Memorandum

Subject	Impact assessment of Winu mining activities on the Wallal Aquifer and environmental receptors		
Date	8 May 2026		
To	Emma McGivern	From	Luke Cowley
CC	Gerhard Jacobs		
Project No	311012-01475	Doc No	311012-01475-HG-TM-048
File Loc	Documents - 311012-01475 Winu Hydrogeology and Hydrology Study\7. Reports and Memos\ 48.Response to ERD Submission\Memo		
Project	Winu Hydrogeology Impact Assessment – Wallal Aquifer

Figure 1-2 Regional Hydrogeology

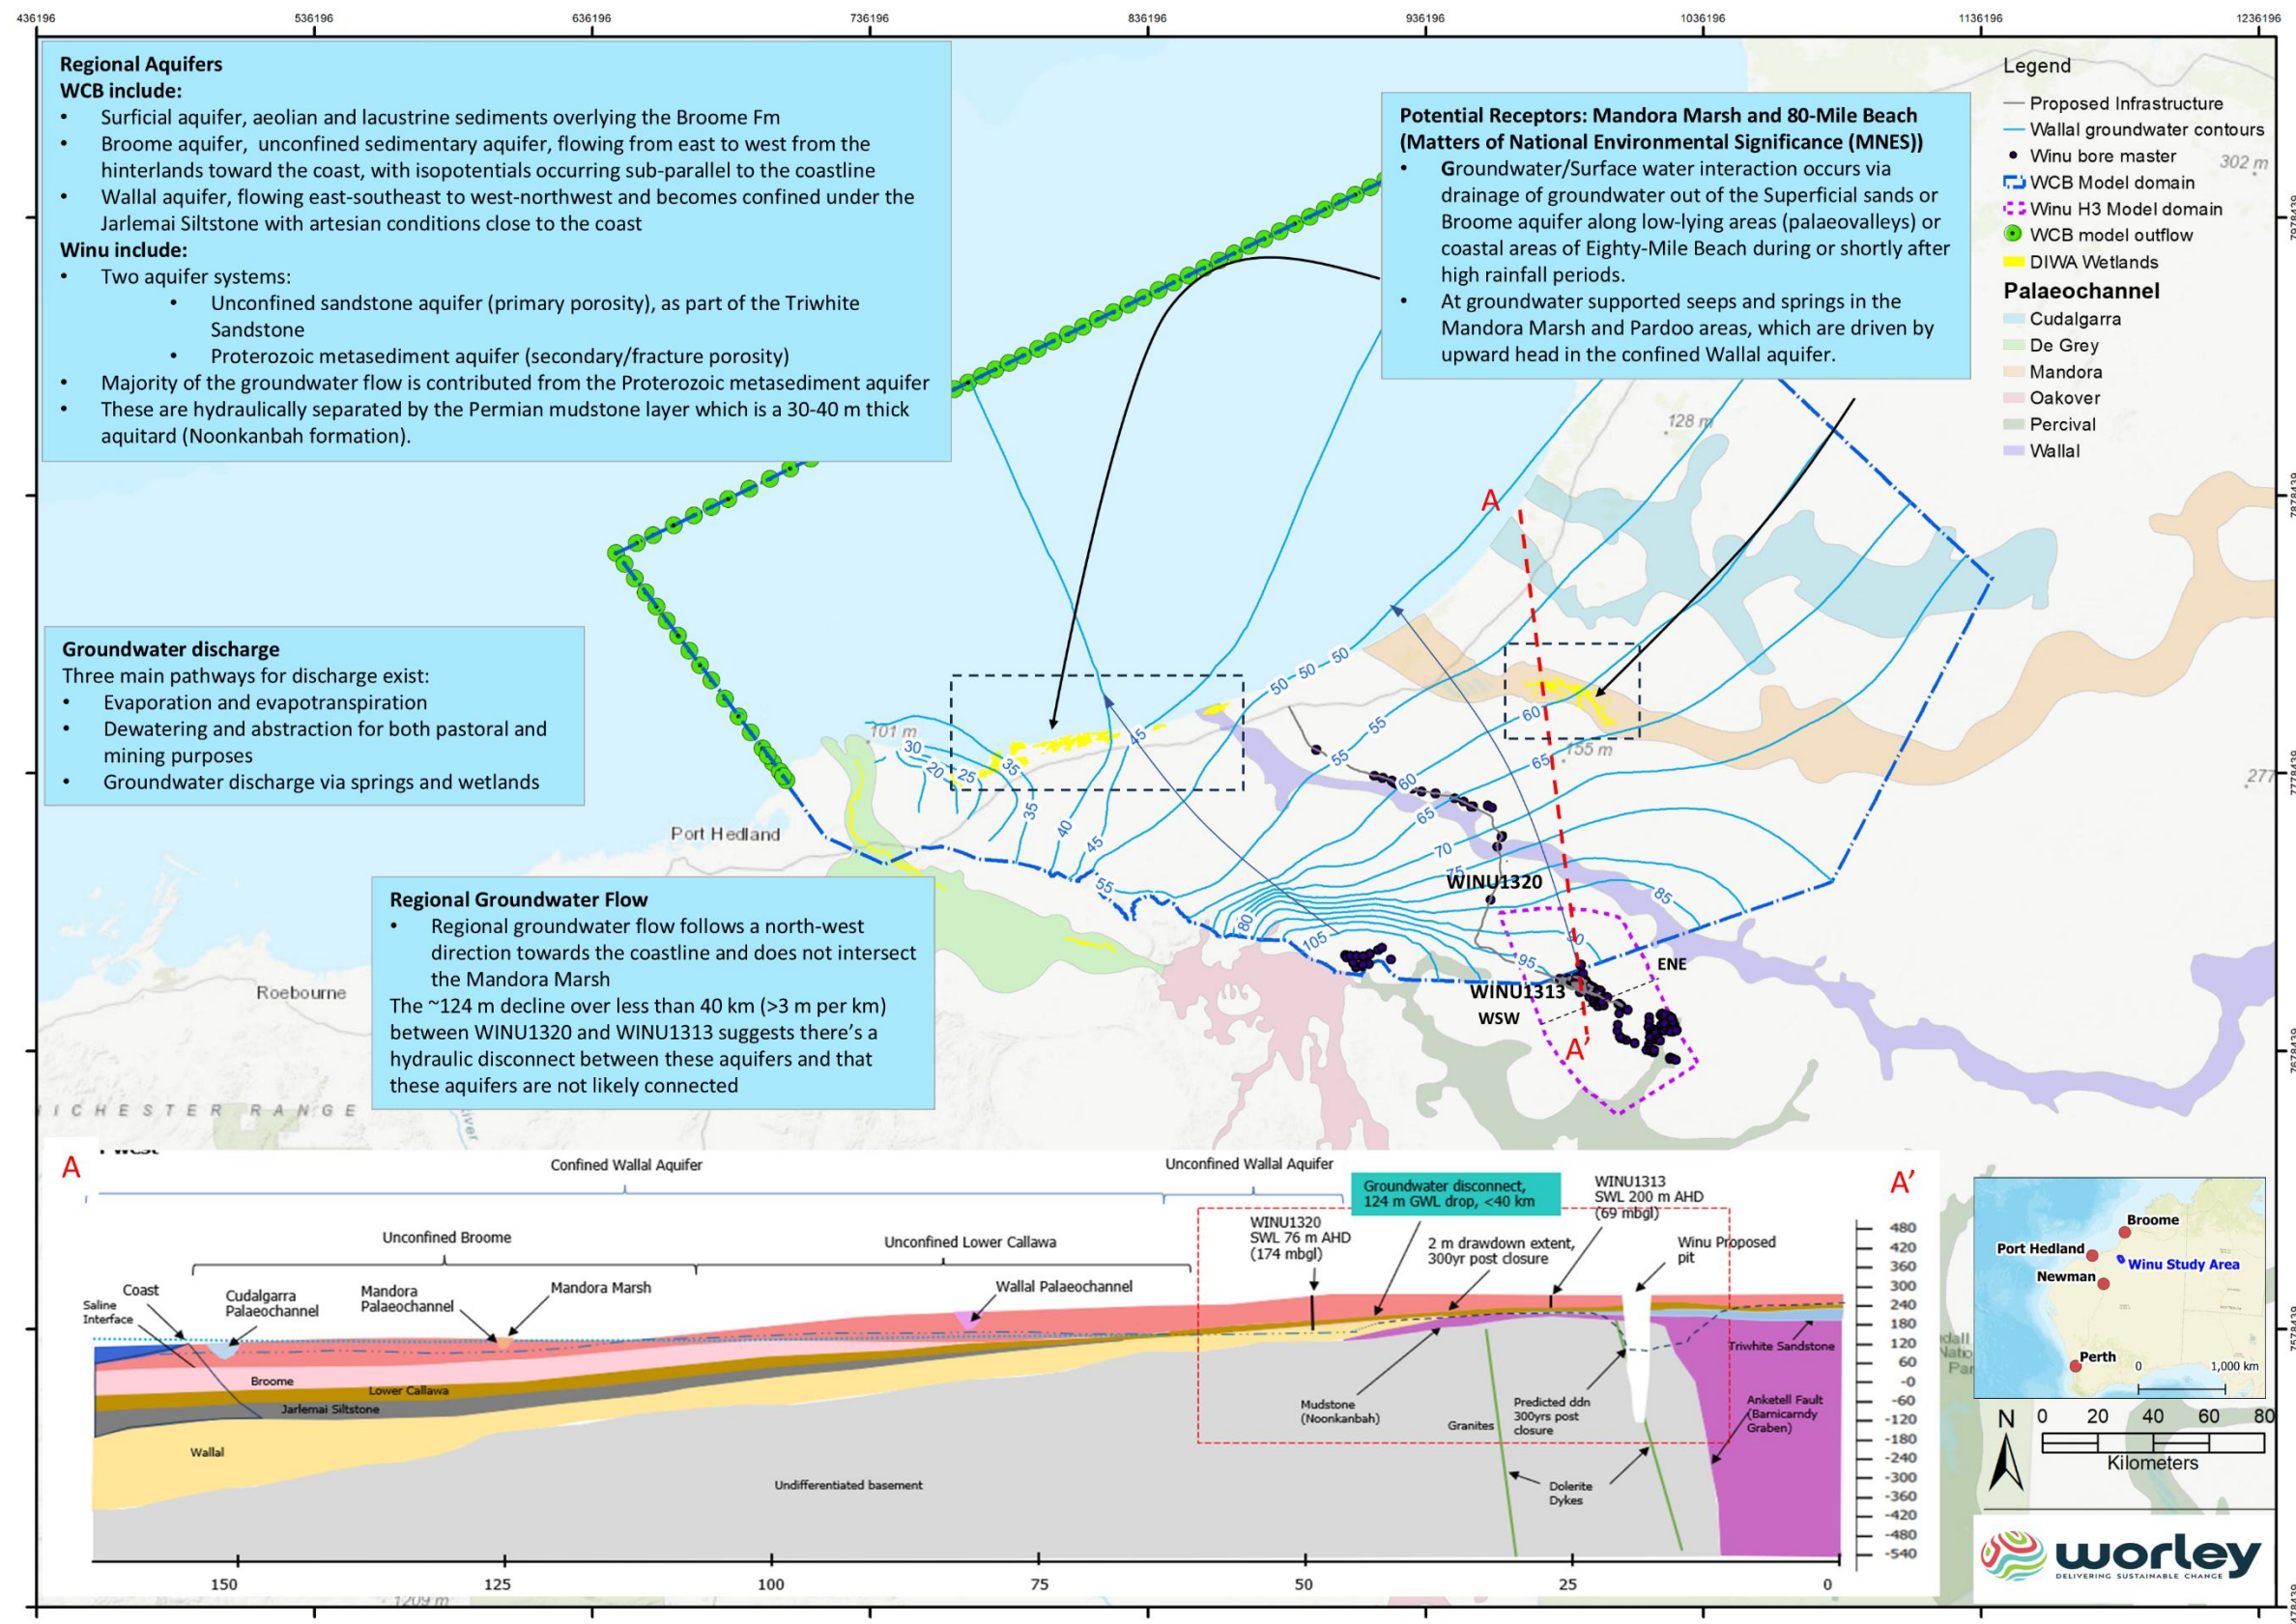
42. ESD requirement 45

a. Confirm if the proposal area occurs in the Wallal aquifer recharge catchment. This could include expanding isotope testing to determine if the proposal area occurs in the Wallal aquifer recharge catchment.

43. ESD requirement 46

a. As for ESD requirement 45, clearly define the location of the proposal with regard to the Wallal aquifer recharge catchment.

Groundwater levels imply regional groundwater flow in the WCB is from the east-southeast to west-northwest, turning perpendicular to the coast. This means that the direction of natural groundwater flow from Winu mine area, west-northwest towards the coast does not intercept Mandora Marsh which is further to the east (Figure 1-2).

These observations strongly suggest the presence of a groundwater divide (geological control) or hydraulic obstruction between the Winu aquifer system and the regional aquifer system to the northeast of Winu (Broome and Wallal).

Regional conceptualisation and groundwater flow gradients suggest that there is a geological control (20-30 km northwest of Winu) between Winu and the Mandora Marsh causing a 124 m groundwater level drop.

Figure 2-2 P90 Predicted drawdown of Winu and Rimfire borefield at LoM, including a 2 m superimposed drawdown contour (red)

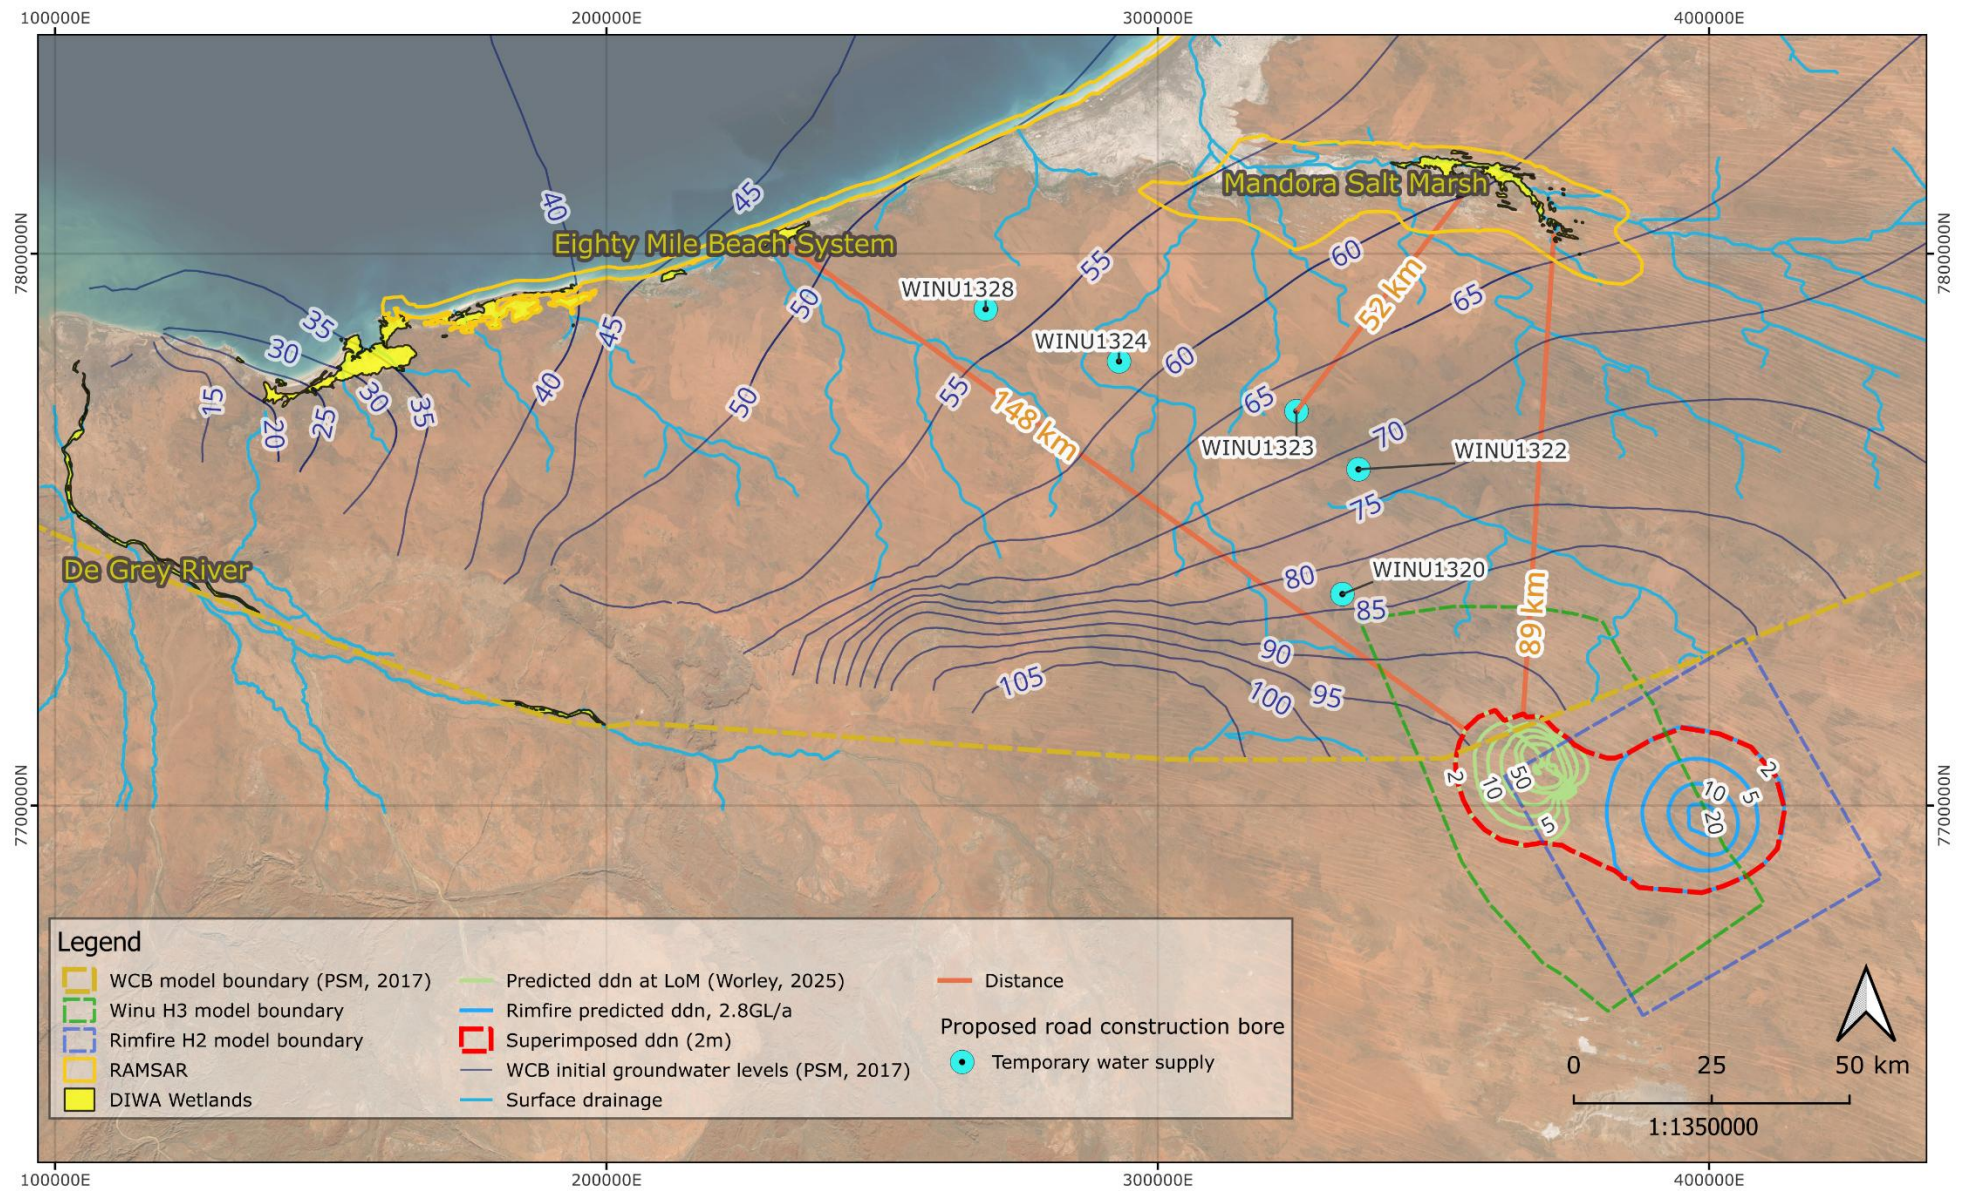
43. ESD requirement 46

c. Provide information that explicitly demonstrates that Eighty Mile Beach Ramsar Wetland will not be impacted, including a drawdown figure that shows the predicted drawdown extent for all operations (MIA and Rimfire), location of the Eighty Mile Beach Ramsar Wetland

Figure 2-2 presents the predicted drawdown at LoM from both Winu (P90, unlikely drawdown extends) and the Rimfire regional borefield (P90, unlikely water demand).

The predicted drawdown associated with the existing regional borefield (Rimfire) and the proposed dewatering at Winu do not spatially overlap. It is acknowledged that as the Rimfire regional borefield and Winu dewatering both draw groundwater from similar geological units, there is a possibility that groundwater abstracted from Rimfire will reduce throughflow in the aquifers at Winu (Figure 2-2).

To adopt a precautionary approach, the drawdown contours from both sources have been superimposed and assume a hypothetical extension of the 2-metre drawdown envelopes until they intersect. This represents a conservative "worst-case" scenario that deliberately overstates potential interaction.

Even under this conservative P90 assumption, the predicted extent of drawdown remains confined to the Proterozoic metasediment aquifer.

Importantly, the furthest extent of the 2-metre drawdown contour is ~90 km south of the Mandora Marsh (Figure 2-2).

Therefore, predicted drawdowns do not extend to Mandora Marsh or Eighty Mile Beach and are unlikely to have an influence on them.

Figure 2-5 Predicted residual drawdown at year 300 post-closure

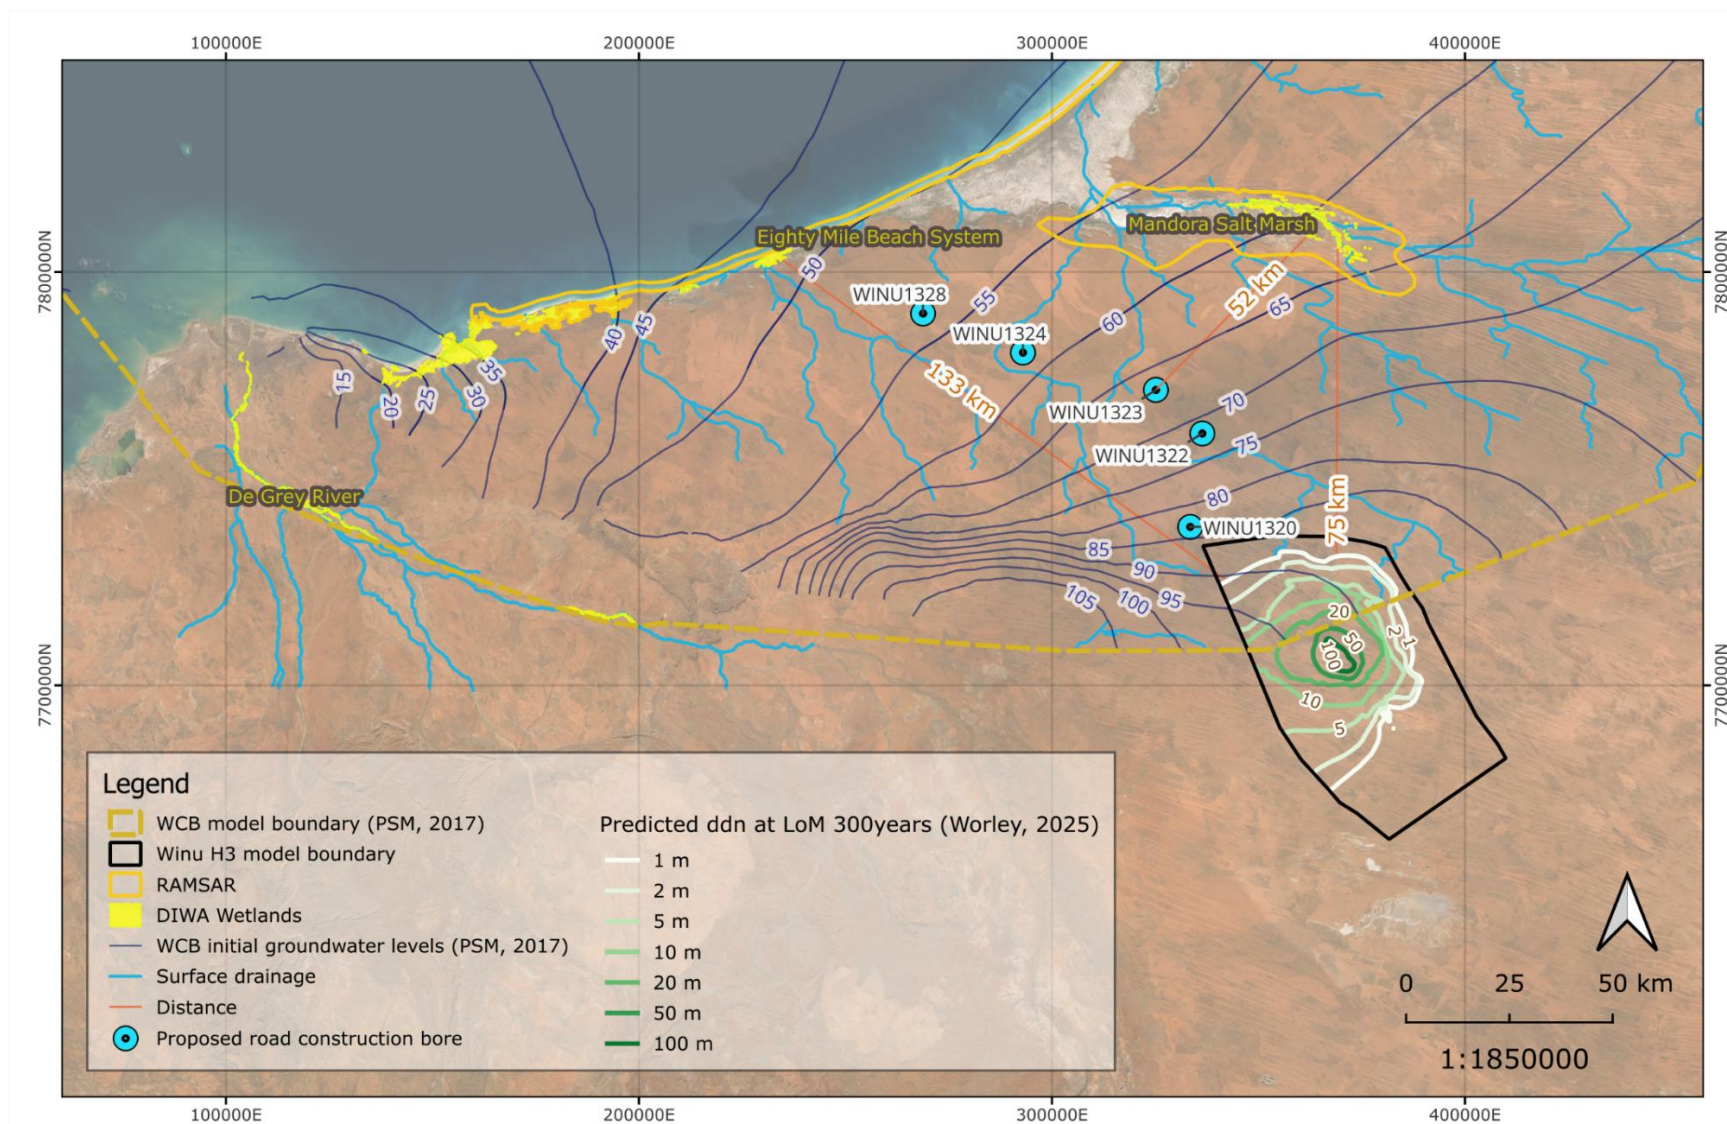
49. ESD requirement 56

a. Given the creation of a permanent pit lake with continued propagation of groundwater drawdown (pg. 214, pg. 234) if the proposal occurs within the Wallal aquifer recharge zone (ESD requirement 45, 46), quantify the extent of the recharge catchment that may be impacted, and impacts to any Wallal aquifer receptors (if any).

For this assessment we have assumed a high permeability scenario, with partial flow barriers, allowing groundwater drawdown to propagate further.

Under this scenario, the 2 m residual drawdown extends up to approximately 14 km at Year 50, 20 km at Year 100 and 22 km at Year 300 Figure 2-5, which is still some 75 km from the Mandora Marsh.
